# Moolarben OC3 Extension Project

State Significant Development Assessment Report (SSD-33083358)

December 2025

**Figure 12 |** Areas of further avoidance recommended for consideration by the Mining Panel

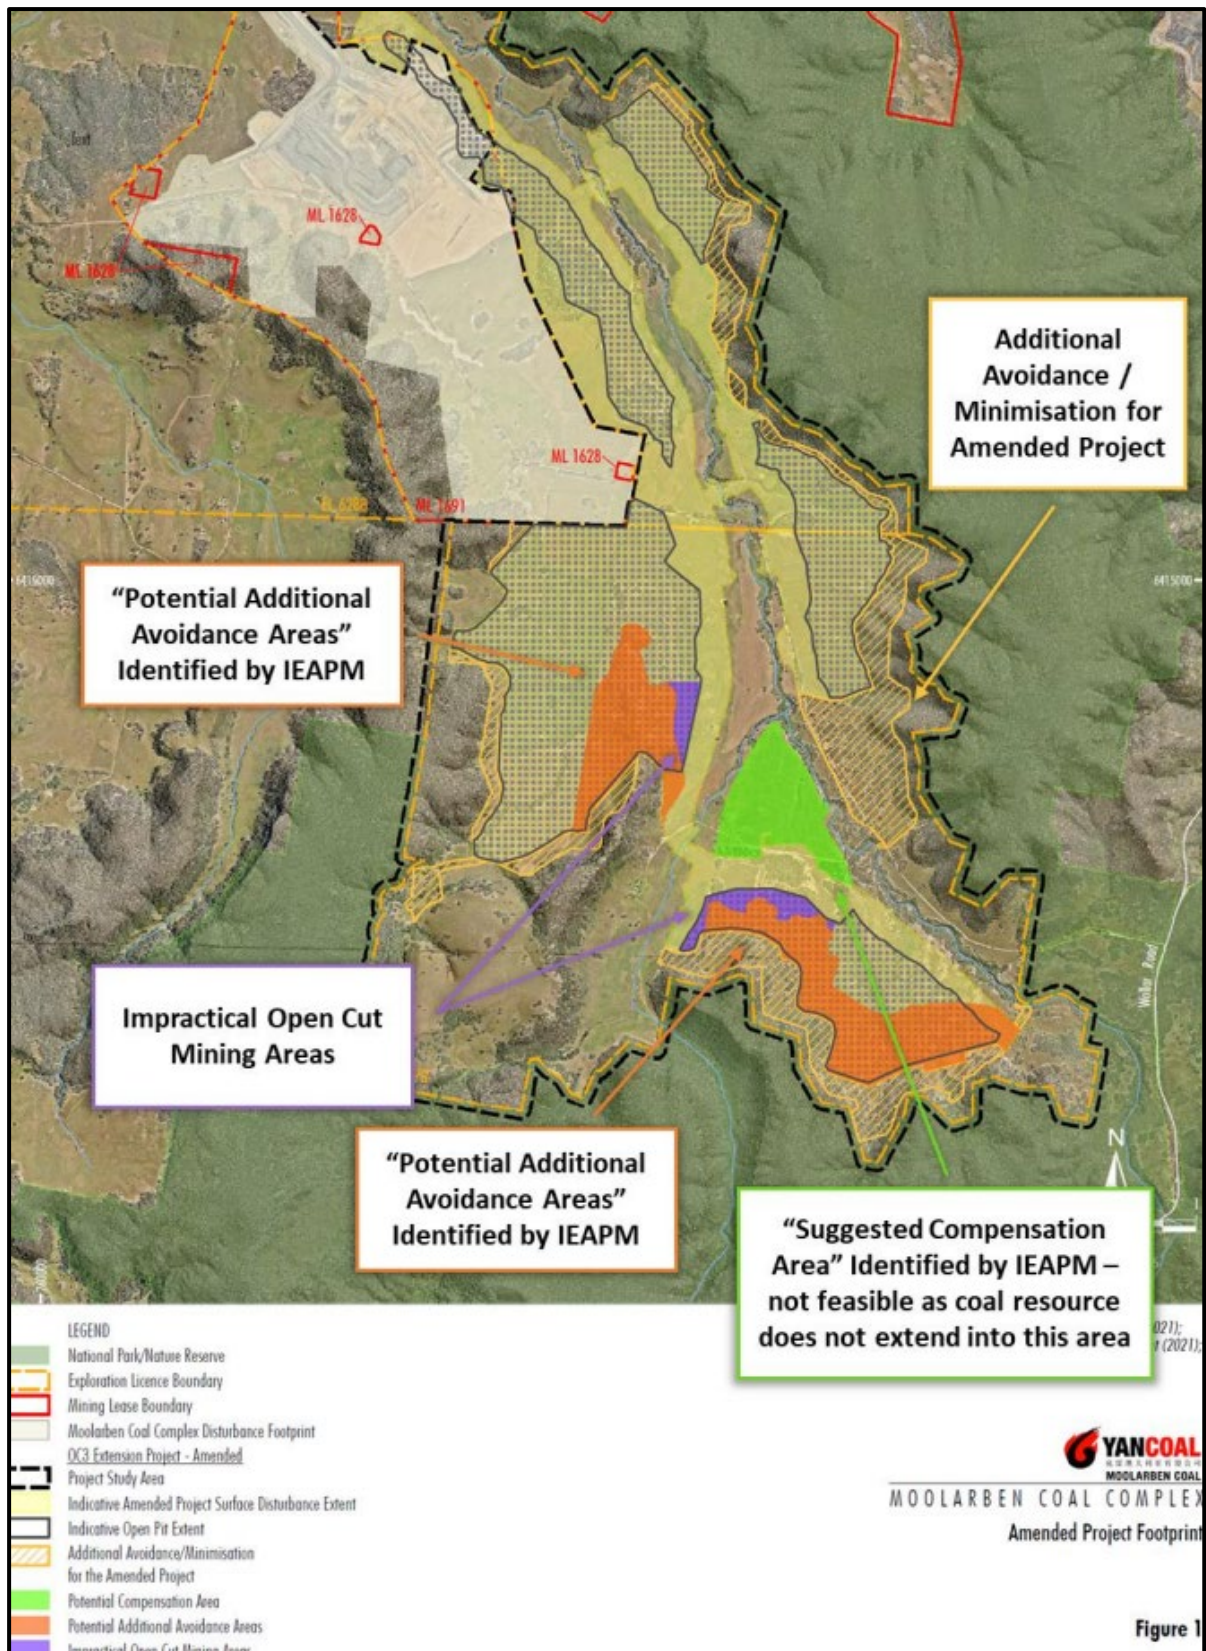
137. CPHR consider that MCO has not undertaken all reasonable avoidance and that further avoidance should be considered in the Stage 3 disturbance area (see **Appendix E - Figure E1**) to reduce impacts on Box-Gum Woodland CEEC and Regent Honeyeater habitat. This area was also identified by the Mining Panel as an area for further consideration, additional to another potential avoidance area within the Stage 1 disturbance area. However, it was acknowledged by the Mining Panel that the identified areas were solely based to the location of vegetation within the project area and that their removal may not be feasible due to other project constraints.

138. Additional avoidance of the proposed areas would have a substantial impact on resource extraction, project layout and final landform initiatives to backfill the approved OC3 void. MCO also advised that the proposed compensatory area identified by the Mining Panel did not

contain any coal resource (see **Figure 12**). This is consistent with the layout of resource presented in the JORC Summary (EIS - Attachment 12).

139. The Stage 3 area contains fragmented patches and edges of mapped 'important habitat' for the Regent Honeyeater. Some of this habitat coincides with the woodland component of Box-Gum Woodland CEEC. Remaining areas in Stage 3 consist predominantly of Box-Gum Woodland DNG or Category 1 land.

141. In the case of Box-Gum Woodland, the Department generally agrees that the avoidance of this stage would not provide an environmental benefit that would warrant such implications to the project. This is because the area has previously been subject to disturbance from agriculture and cropping activities and there is a high degree of fragmentation of the woodland CEEC components. Additionally, residual quantities of Box-Gum Woodland that would be affected by the project would be negligible (<0.01%) in the context of the remaining extent of the entity in NSW.

**Figure 13 | Areas proposed for potential inclusion in the Habitat Enhancement Area**

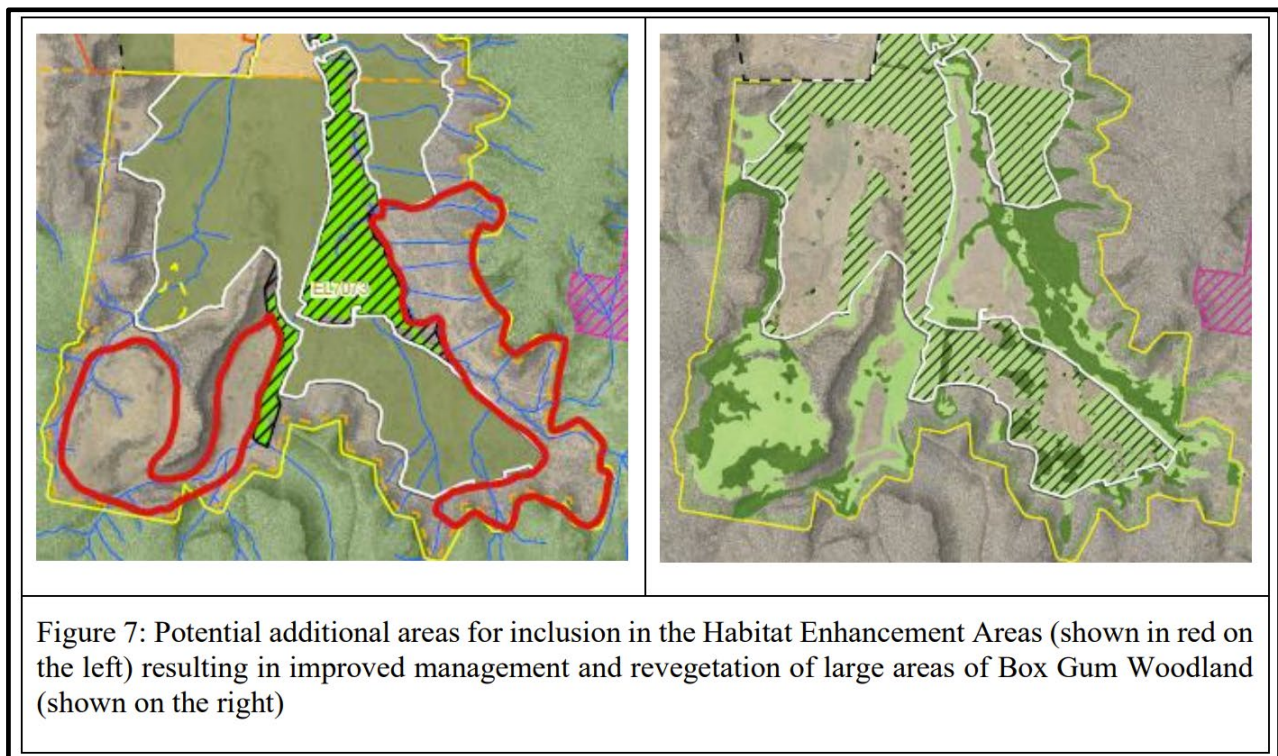
148. The Mining Panel suggested that the consent authority may wish to consider requiring an equivalent amount of disturbed Box-Gum Woodland (ie 401.2 ha) to be protected and enhanced within the proposed habitat enhancement area. This approach was suggested to ensure that the project does not result in a reduction in the geographic range of Box Gum Woodland CEEC or the further environmental degradation, specific to Principle 2 of Clause 6.7 of the BC Regulation.

149. Two areas of Box Gum Woodland within the study area were identified by the Mining Panel for potential inclusion in the habitat enhancement area (see **Figure 13**). MCO identified that one of these areas (left red polygon on **Figure 13**) consists mostly of DNG that sits atop of a basalt plug which would constrain revegetation of this area to achieve woodland formation. The other area (right red polygon on **Figure 13**) lies in between the proposed project stages and the Munghorn Gap Nature Reserve and is mostly in woodland formation.

150. The Department considers that the inclusion of these areas could be considered reasonable, however only for enhancement of the CEEC in its existing form. This is because:

- their inclusion would provide a good outcome for the valley by retaining connectivity of Box Gum Woodland across the valley floor, post mining;
  - their inclusion would result in an equivalent amount of Box Gum Woodland retained within the valley to that which would be disturbed by the project. This would be additional to offsetting requirements;

**Figure 18 | Predicted extent of incremental 2 m drawdown – sensitivity analysis**

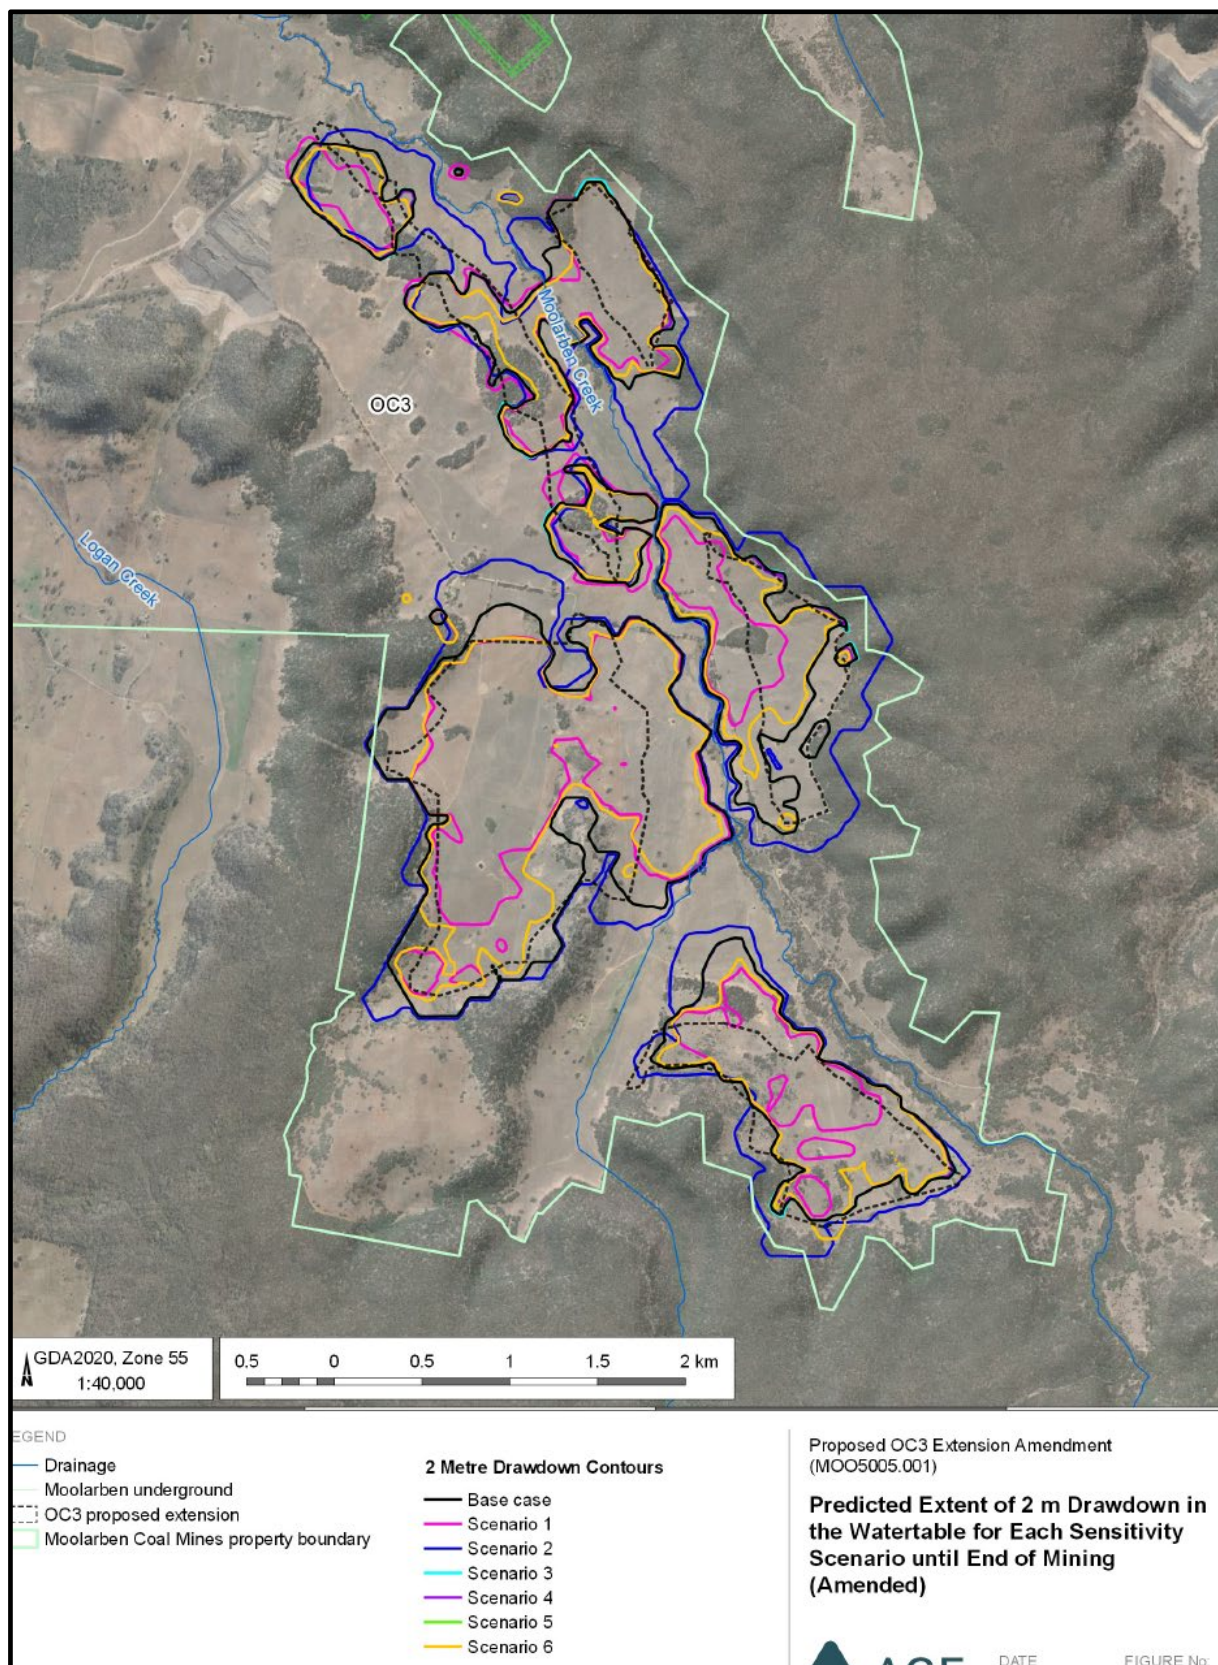
255. Baseflow predictions were queried by the IESC and Mining Panel due to the low confidence in modelling of local scale impacts. The inclusion of sensitivity analysis provides an indication of how different variables may affect the baseflow quantities. However, on-ground impact of these baseflow reductions would predominantly be on local groundwater dependent ecosystems, as discussed above.

256. Consistent with advice from the Mining Panel, the Department has, should the IPC determine to approve the Project, recommended a condition requiring a revised numerical model within 18 months of the installation of the new monitoring sites to improve predictions and conceptual understanding of the project area.
